CITY OF WESTMINSTER			
PLANNING APPLICATIONS COMMITTEE	Date 14 June 2016	Classification For General Release	
Report of Director of Planning		Ward(s) involved Knightsbridge And Belgravia	
Subject of Report	11 Upper Belgrave Street, London, SW1X 8BD,		
Proposal	Internal and external alterations including creation of a garage on the Wilton Street elevation with associated crossover, a rear extension at fourth floor level and enlarged roof terrace at fifth floor level in connection with the use of the property as a single family dwelling. excavation works at lower ground floor, rebuilding of ground floor rear infill addition, rear extension at first floor and third floor levels, creation of terraces at first and roof levels, and installation of condensers at roof level		
Agent	Ms Rosalind Price		
On behalf of	Waltonwagner Limited		
Registered Number	16/02481/FULL 16/02482/LBC	Date amended/ completed	31 March 2016

Refuse permission and listed building consent – design and heritage impact

Proposed ground floor

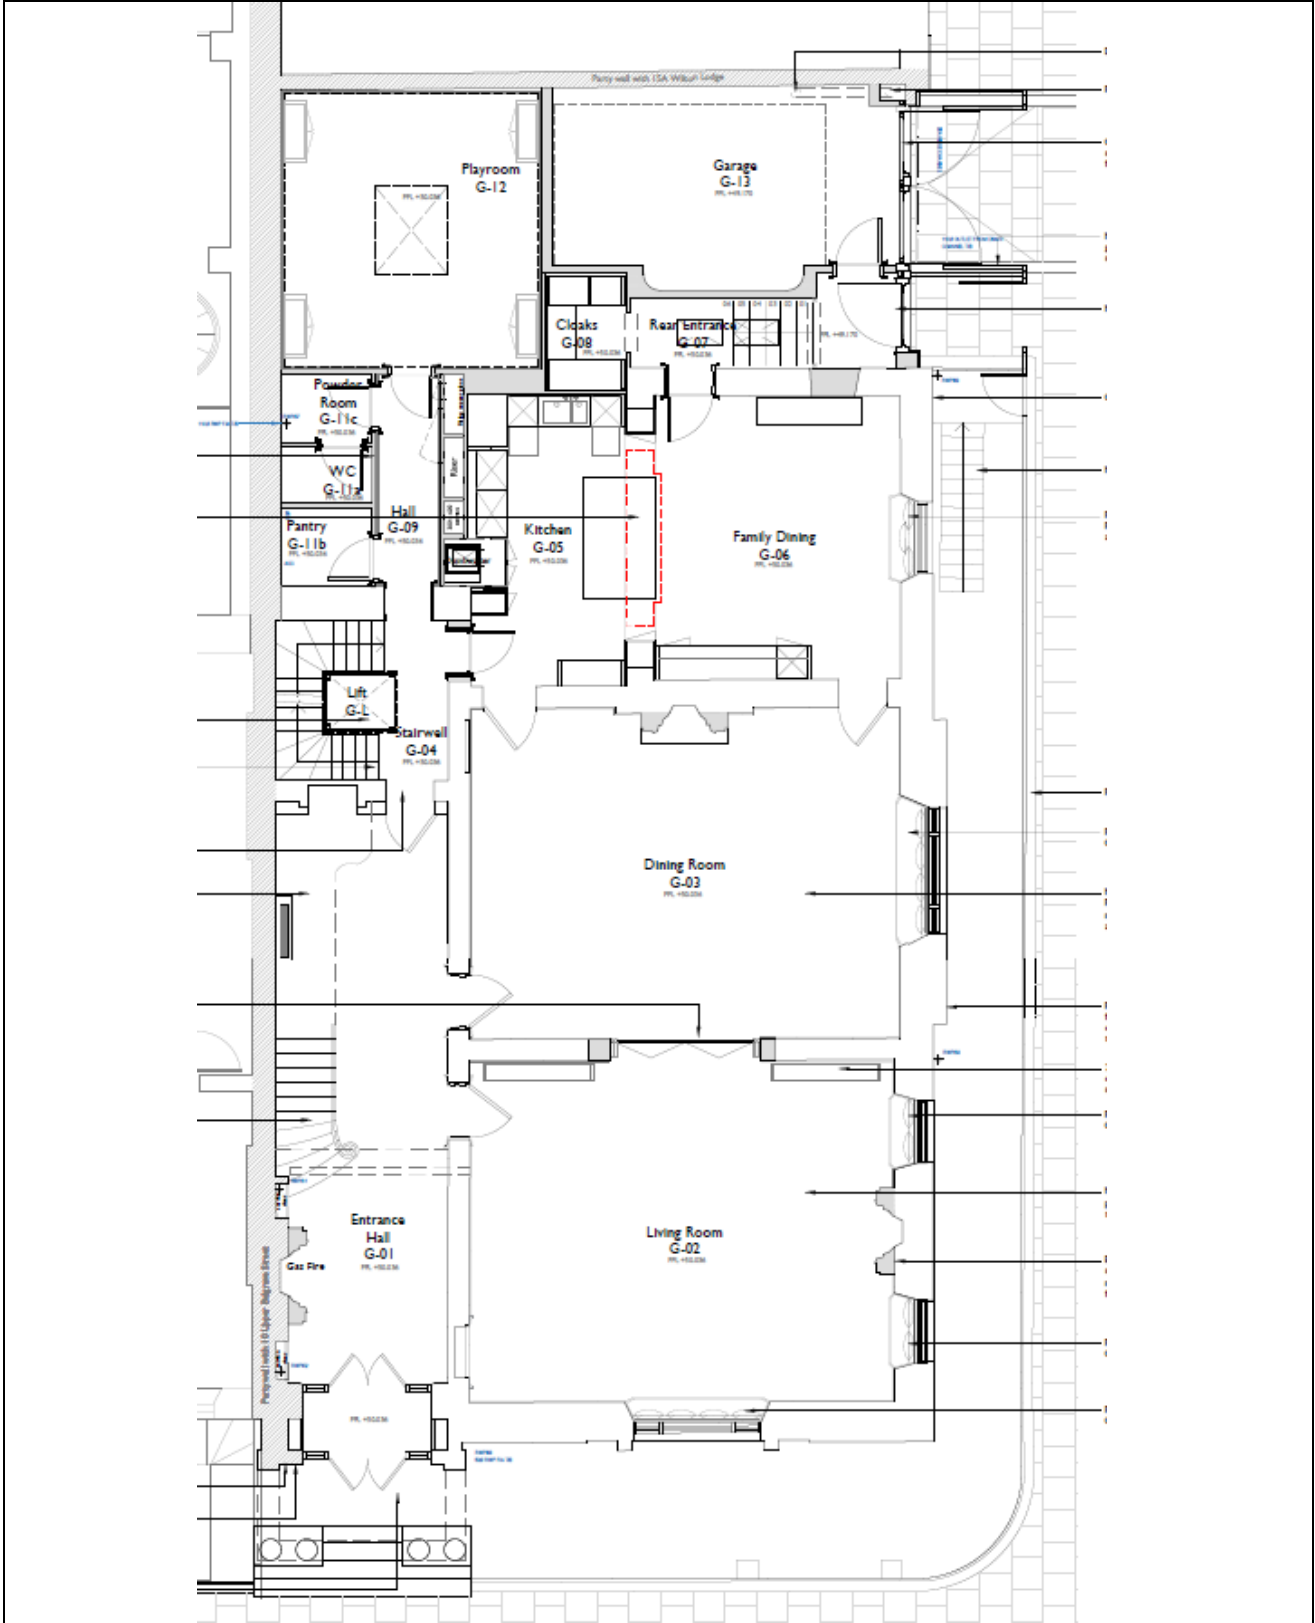
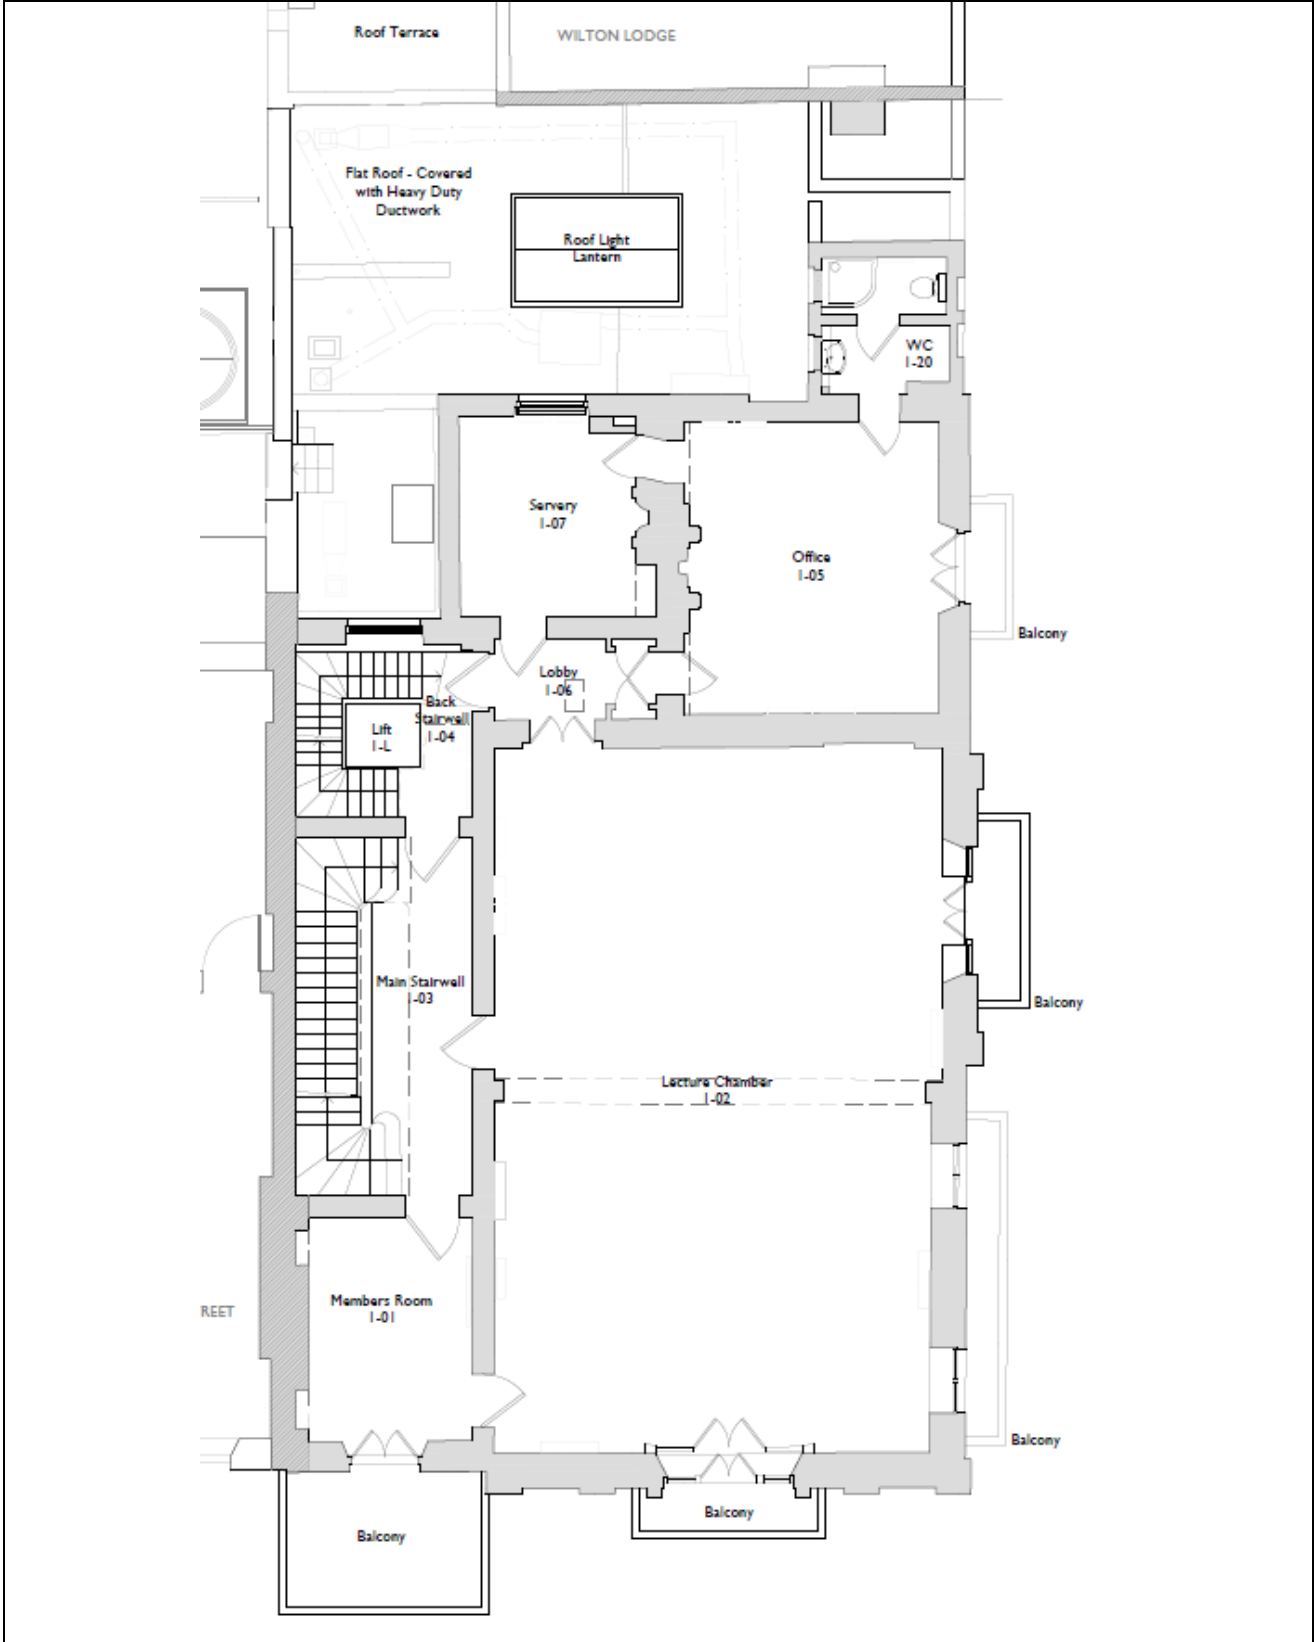
Approval is sought to remove an internal wall and chimney breast, leaving shallow nibs and a downstand from the ceiling, to create a larger Family Kitchen / Dining Room. As approved by the original consents, these two spaces would have remained separate but linked via enlarged openings each side of the chimney breast.

The rooms affected are secondary rooms, but are characteristic of the cellular planform, more modest rooms typical towards the rear of a house of this type. The proposal would result in a significant loss of historic fabric, most particularly in the form of the chimney breast which projects from the side walls. Whilst the nibs and downstand would provide some interpretation of the rooms' historically separate form, the character of the resultant space would be effectively that of one room, so losing the distinctive small cellular planform to this part of the house.

Because of the alterations to the historic plan form and spatial character of the building's interior, the removal of the walls between the proposed kitchen and family dining room at ground floor level would harm the character and special interest of this grade II* listed building. This would be against the advice set out in S25 and S28 of Westminster's City Plan: Strategic Policies adopted November 2013 and DES 1 of our Unitary Development Plan that we adopted in January 2007 and the advice set out in paragraphs 6.18-6.20 of our 'Supplementary Planning Guidance: Repairs and Alterations to Listed Buildings'. (X18AB)

Proposed first floor plan

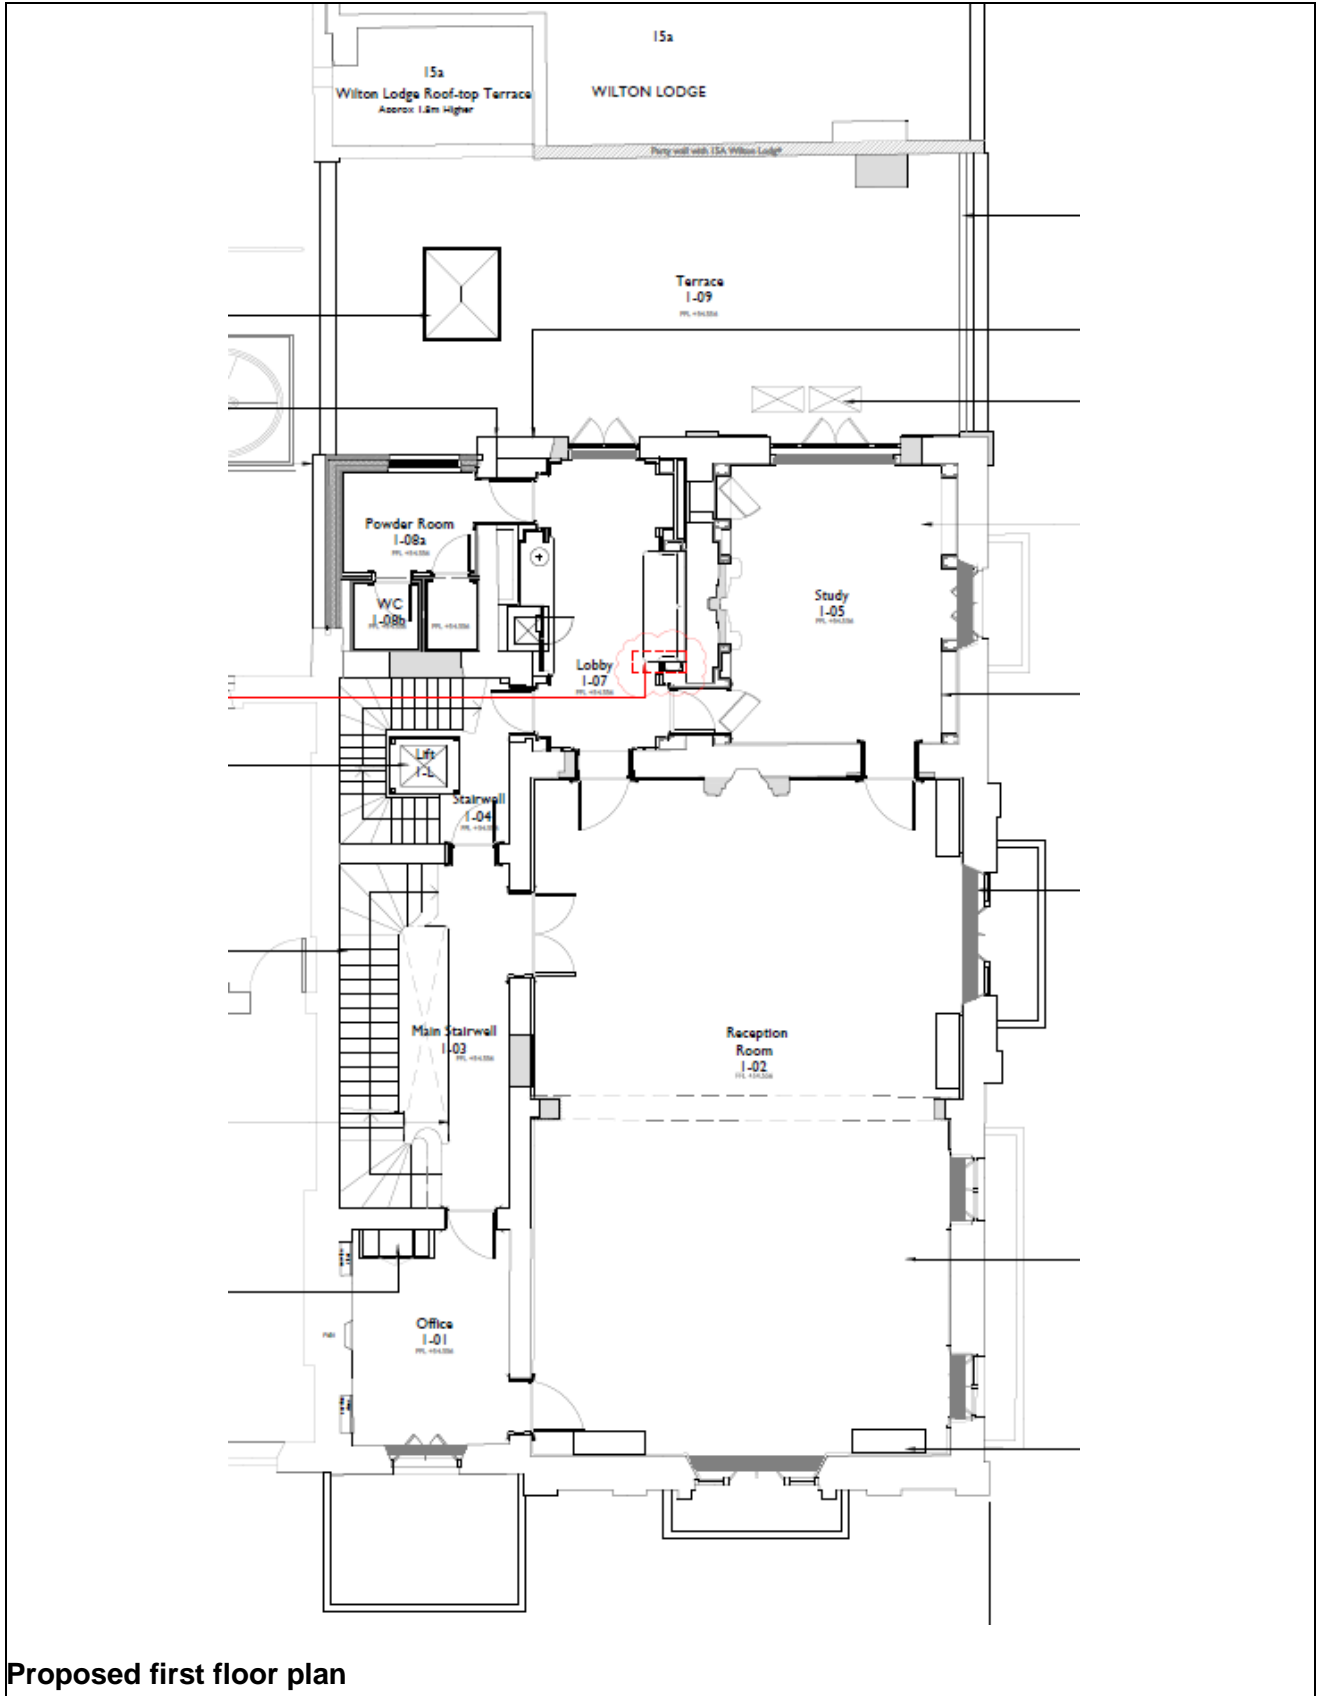
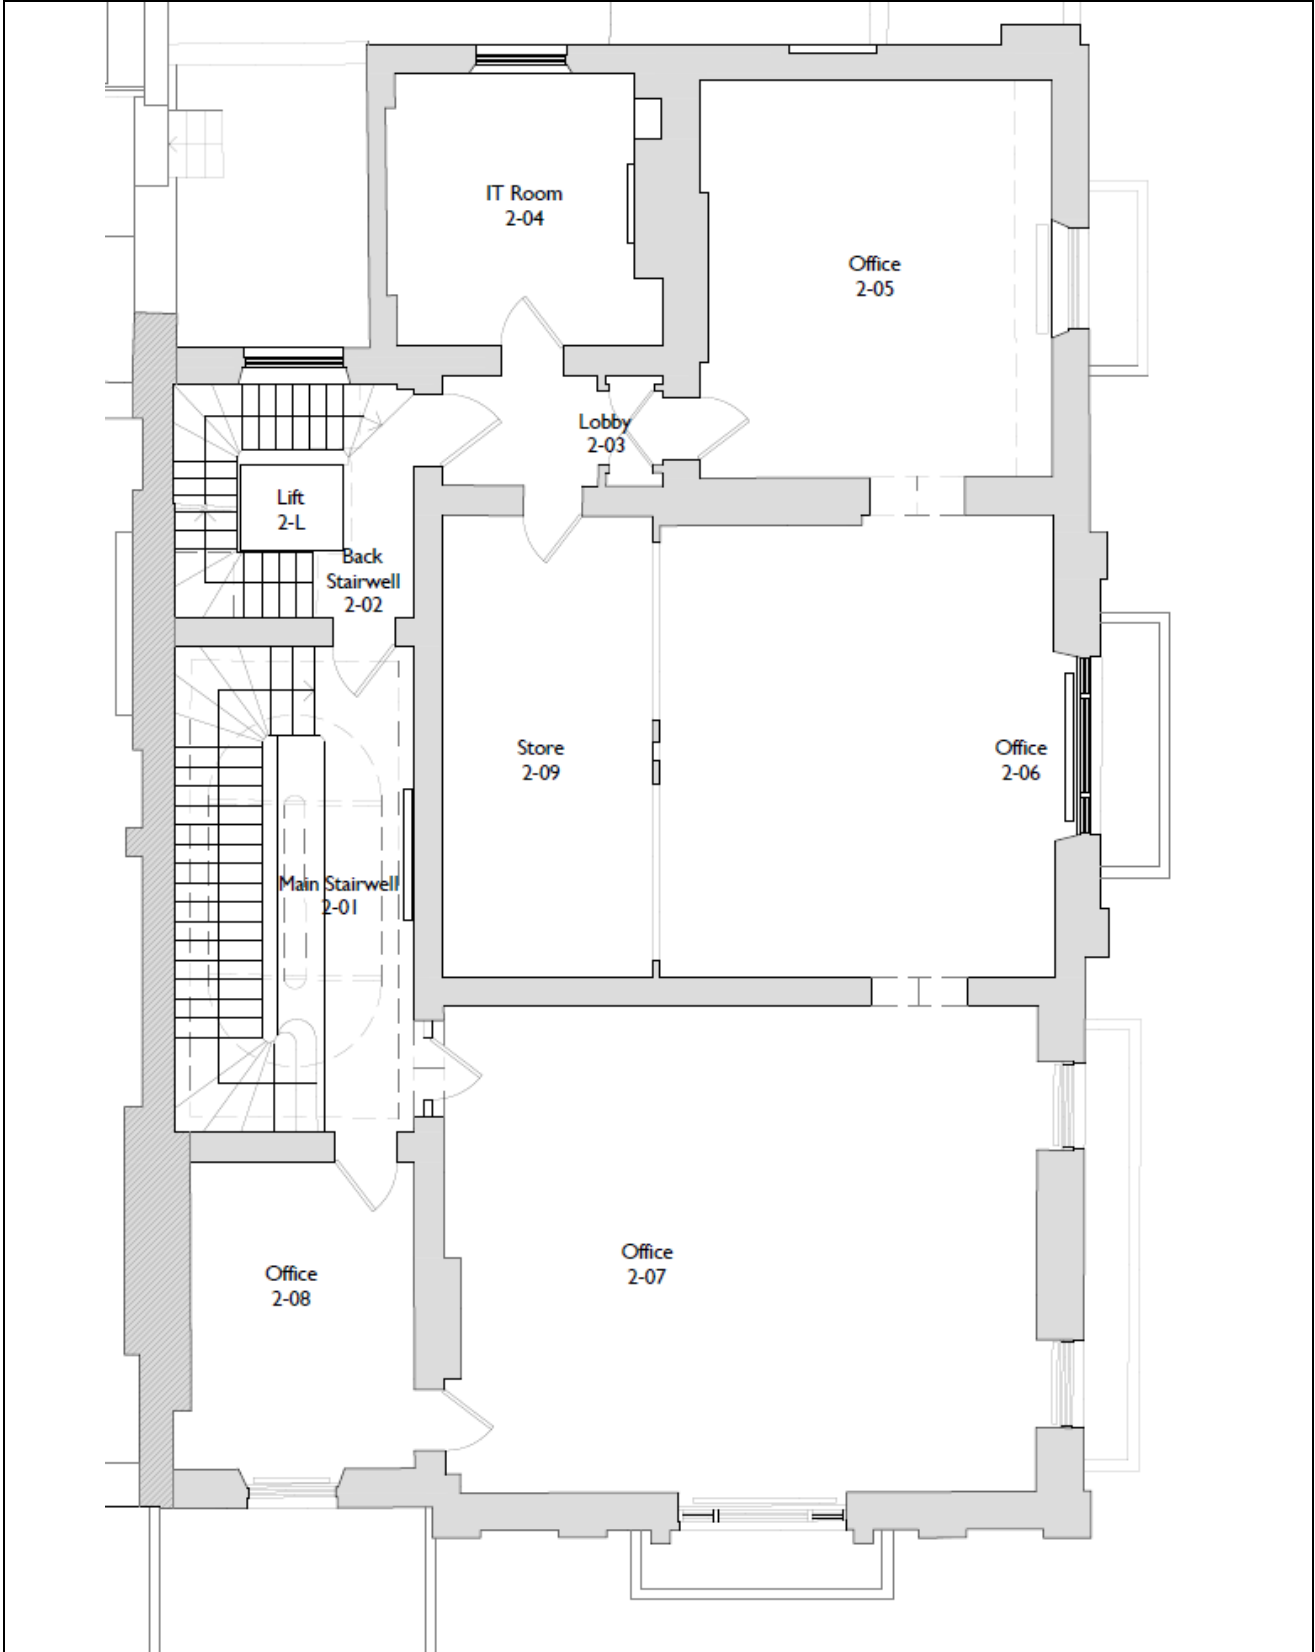
To the first floor it is proposed to remove the wall which separates the Garden Room from the inner lobby, and to build into the space a highly designed set of suspended ceilings and wall linings, to link the first floor external terrace through the principal Reception Room without having to traverse the separate lobby.

The layout of this space is important to the cellular planform of the building, as are the internal proportions of the Garden Room. The proposals would wholly overwhelm the character of this space, concealing the attractive cornicing which defines the room and deleting the understanding of the planform in this part of the house.

Because of the alterations to the historic plan form and spatial character of the building's interior, the removal of the walls between the proposed garden room and lobby at first floor, would harm the character and special interest of this grade II* listed building. This would be against the advice set out in S25 and S28 of Westminster's City Plan: Strategic Policies adopted November 2013 and DES 1 of our Unitary Development Plan that we adopted in January 2007 and the advice set out in paragraphs 6.18-6.20 of our 'Supplementary Planning Guidance: Repairs and Alterations to Listed Buildings'. (X18AB)
